*Class V Treated Water Infiltration System Application Review*

**The Cadmus Group, Inc.  
57 Water Street  
Watertown, MA 02472**

**Final Report**

**June 12, 2008**

**Figure 1. Site location with watershed boundaries, wetlands and selected monitoring wells.**

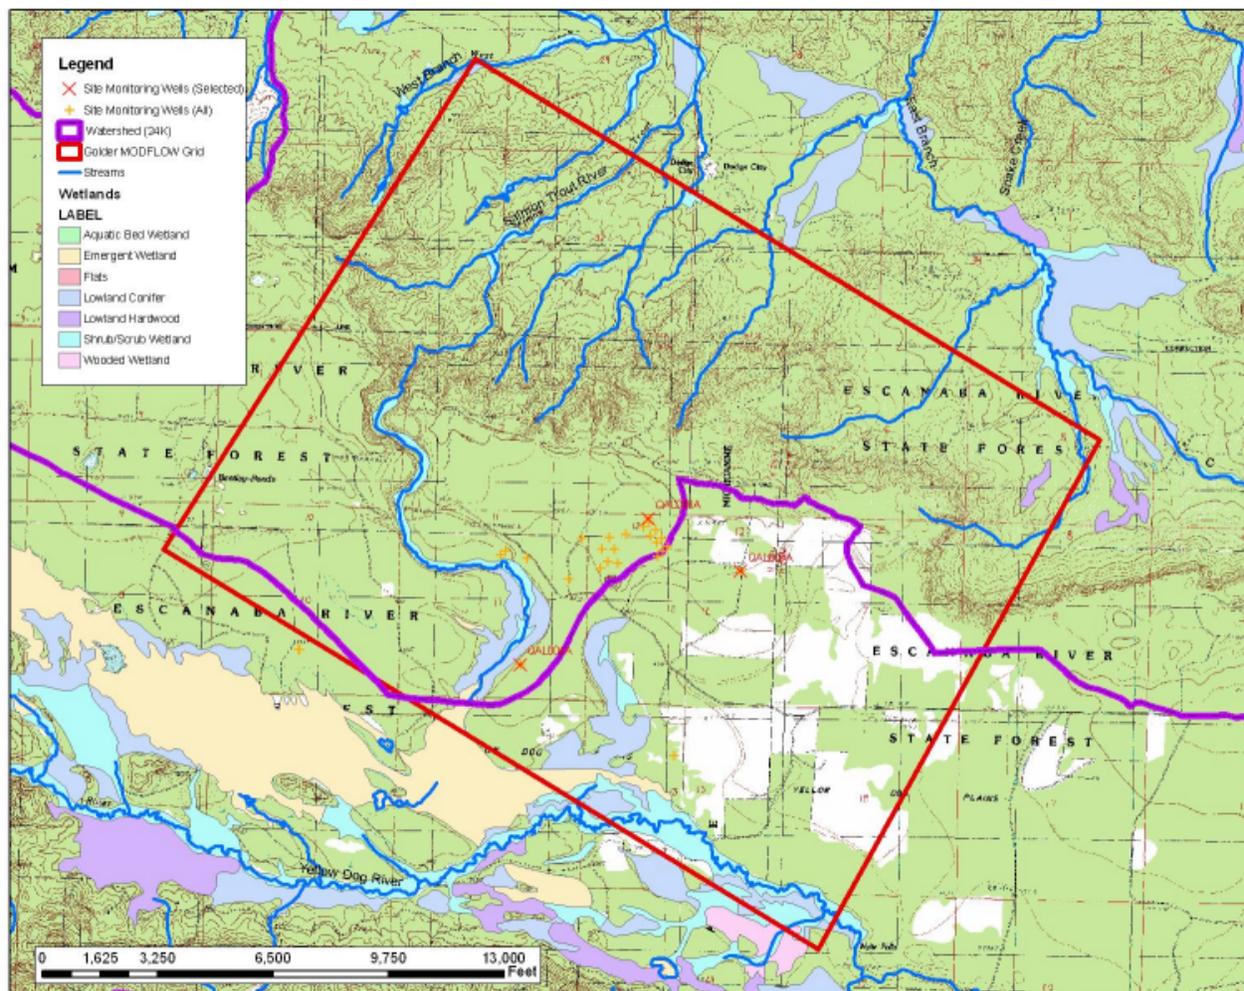
Figure 1, below, was created using readily available GIS files ([www.mcgi.state.mi.us/mgdl](http://www.mcgi.state.mi.us/mgdl)) and Table 1 from North Jackson. The model grid is approximately the Golder model. Note that the watershed boundaries are significantly different from the groundwater divide presented in the two modeling reports.

It is not clear whether the numerical model included the Peridotite dike. Because the predicted contour lines do not show breaks, it is likely that this intrusion was not incorporated into the model. The model underpredicts the mounding in close proximity to the dike.

Figure 2 Spatial Distribution of Infiltration Mound for Input Scenario 2.

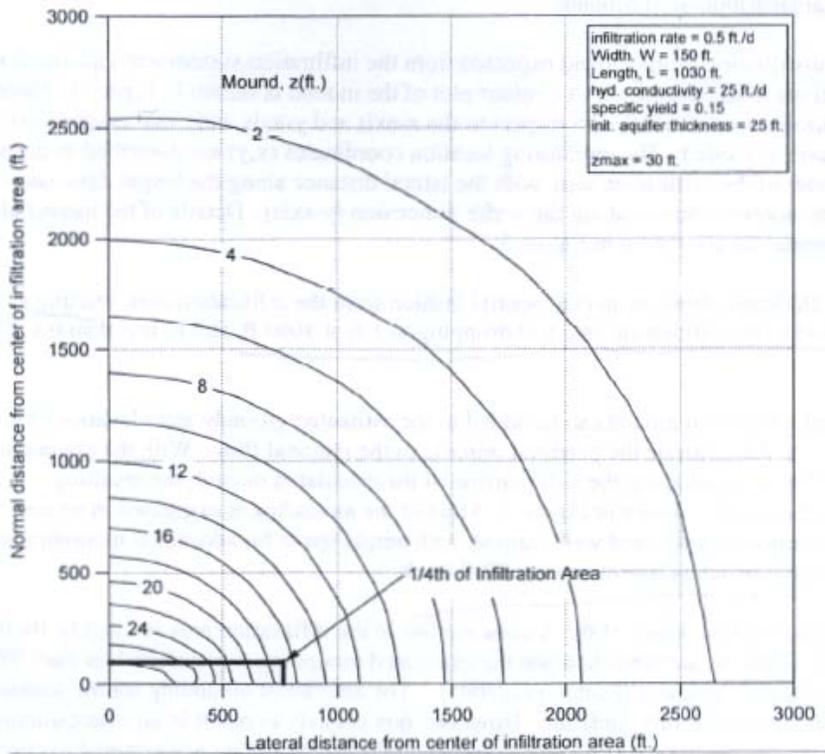
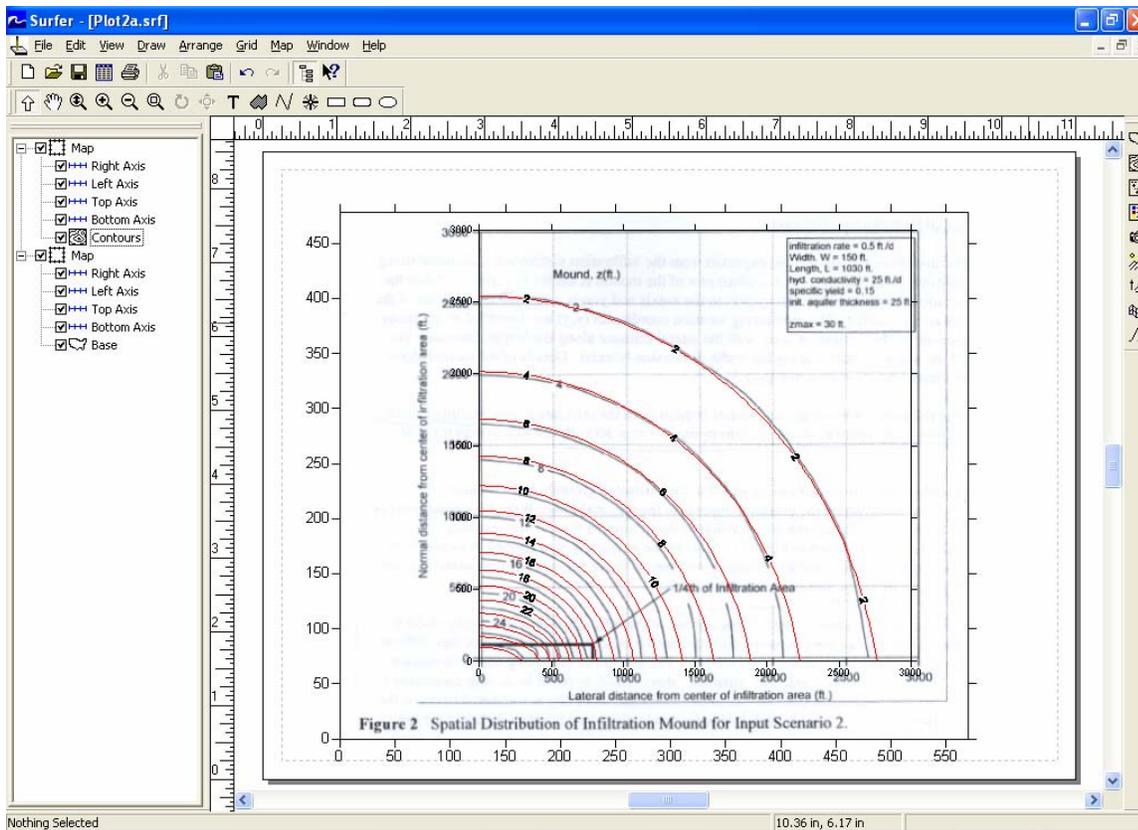
Additionally the shape of the groundwater mounds is compared. The original models provide for contours of the mound for Scenario 2. The rectangular area is 150 x 1027 feet. There appears to be a slight error in F&VD Figure 2. The  $\frac{1}{4}$  patch rectangle should be 75 x 514 feet, but appears to be approximately 75 x 750 feet.

Using AQTESOLV (shown in red), similar results are obtained as shown below. Except for differences resulting from the contouring approaches used, the results are very similar. This indicates that the two sets of calculation results are consistent and probably correct.

Figure 2. Conceptual Hydrogeological Cross Section C-C'. From Foth and Van Dyke, 2006

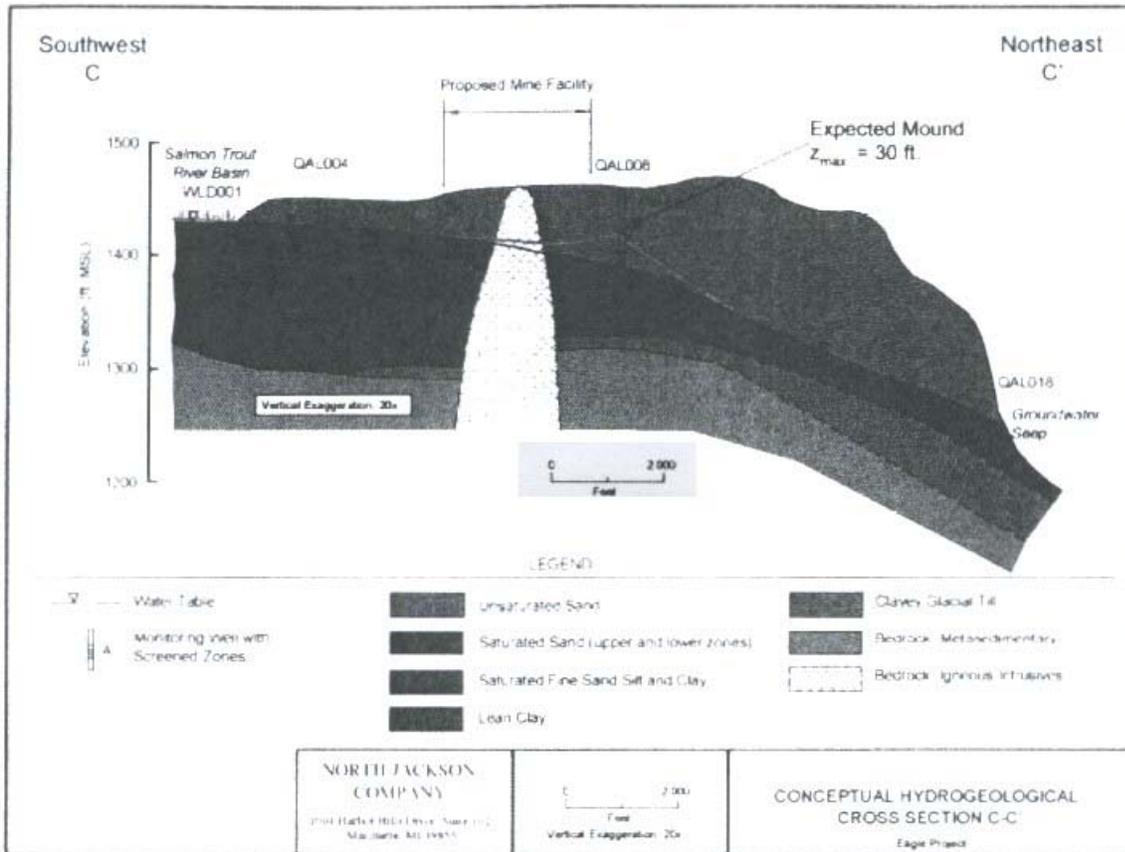
Using AQTESOLV, the analytical model can be further extended to address the effects of boundary conditions. The F&VD analytical solution assumes infinite boundary conditions, however, the Peridotite dike intrusion is located approximately 1,200 feet upgradient of the recharge site and is a potential localized flow barrier.

The dike appears to be located at a point where the predicted mounding is about 9-10 feet as shown in Figure 3 by F&VD.

Figure 3 Detail of Infiltration Mound with Normal Distance (y-dimension) for Input Scenario 2.

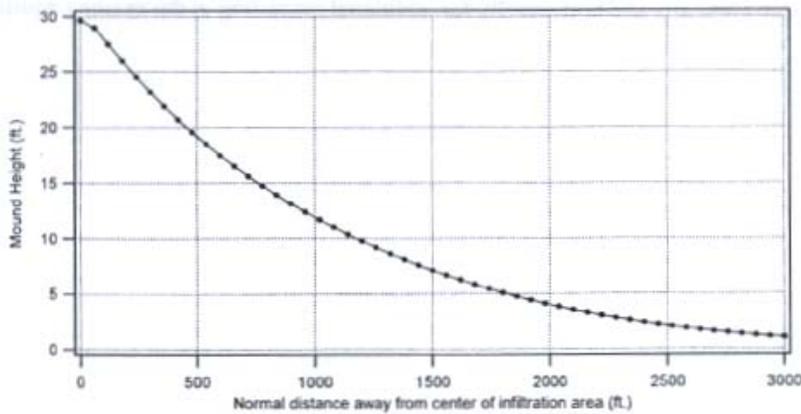
The dike is nominally 500 feet in diameter and most likely behaves more like a partial no-flow barrier. To include this effect AQTESOLV offers boundary condition options. To assess the importance of the dike a test simulation was run in which the dike was assumed to be of infinite extent. A no-flow boundary is established at 1,200 feet as follows:

### Comparison of F&VD and AQTESOLV with no-flow boundary

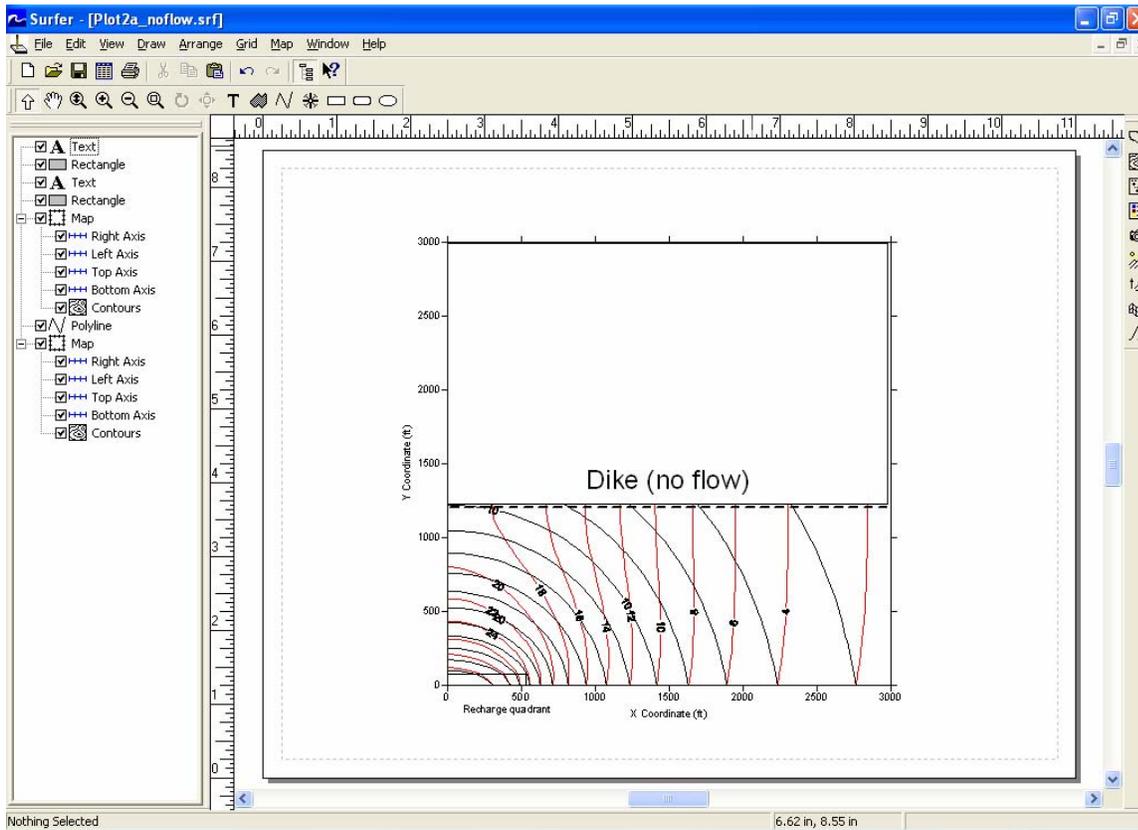
When the dike is added to the model, the mound near the dike increases from 10 to 19 feet although the maximum mound beneath the center of the infiltration zone is nearly unchanged.

This indicates that incorporation of the dike has no significant effect on the height of the mound beneath the infiltration site, but may locally increase mounding in the vicinity of the actual dike.
